Delegated Report

Householder Planning Application

Planning Application No: 20231280

Description: Creation of vehicular crossover with hardstanding.

Proposed

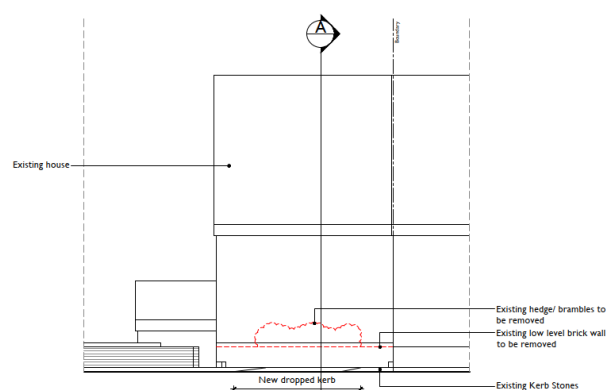
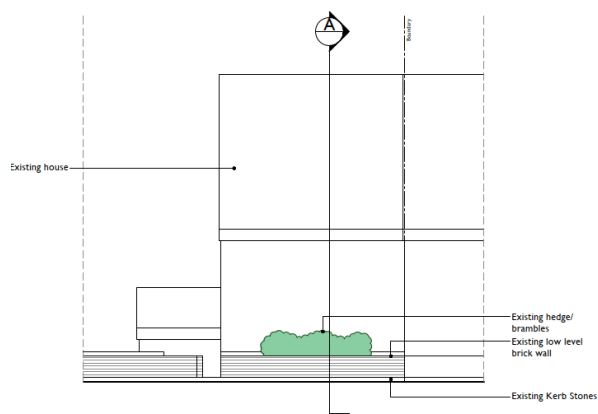
The removal of the laid to lawn front garden and other soft landscaping and its replacement with a hardstanding will result in a hardening of the streetscene which will have a detrimental impact on the visual amenity of the area.

According to KCC Parking Standards 2006 a standard parking space should be 2.5 metres wide by 5 metres deep. The proposed parking space falls below the minimum standards set by the highways authority and is therefore not suitable to accommodate off road parking for a modern day vehicle.

Proposed boundary wall elevation

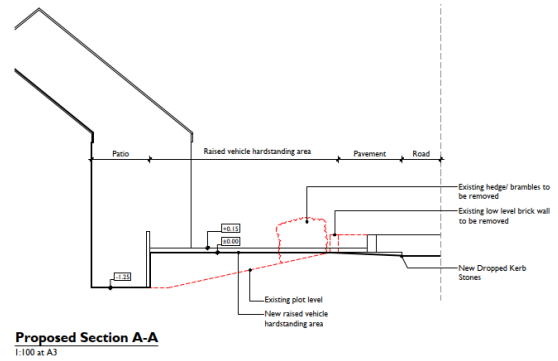
The property is accessible via some downward steps as the level of the highway is higher than that of the property. In order to facilitate the creation of a handstanding the existing garden level will be raised however details on the proposed finishing materials have not been given.

Visibility Splays

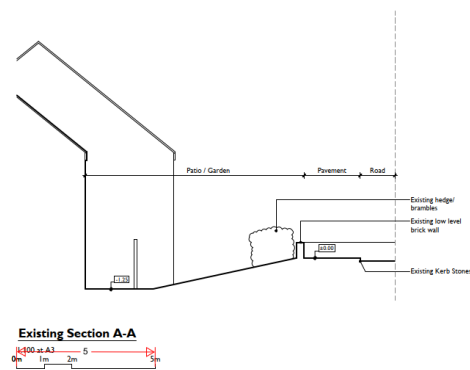
The 'y' distance, the distance measured along the carriageway is from the centre of the driveway and measured along the near side kerb. The 'x' distance is a line perpendicular to the highway down the centre of the drive.

The 'x' distance is 2.4 metres and the 'y' distance is determined by the requirements of Manual for Streets and reflects the speed limit, so for a 30mph road this would be 43metres. However, if speeds are constrained by design a lower provision may be possible. So if vehicles pass the access at 20mph the sight line requirement may be reduced to 25 metres. In truth the visibility at this access would be nearer 20 metres, which equates to a passing vehicle speed of 15mph which is unlikely to be achieved.

Looking to the right on exiting the property there is an inadequate sight line. Looking to the left the sight line should again be measured along the nearside kerb to the tangent point on the kerb line and this would pass over many properties outside the applicant's control. So, the conclusion has to be the application should be refused. Sight line ends here.

In this location it is impossible to provide suitable sight lines for the access.

The proposed visibility splays have been incorrectly shown and it is evident that adequate splays cannot be achieved on site.
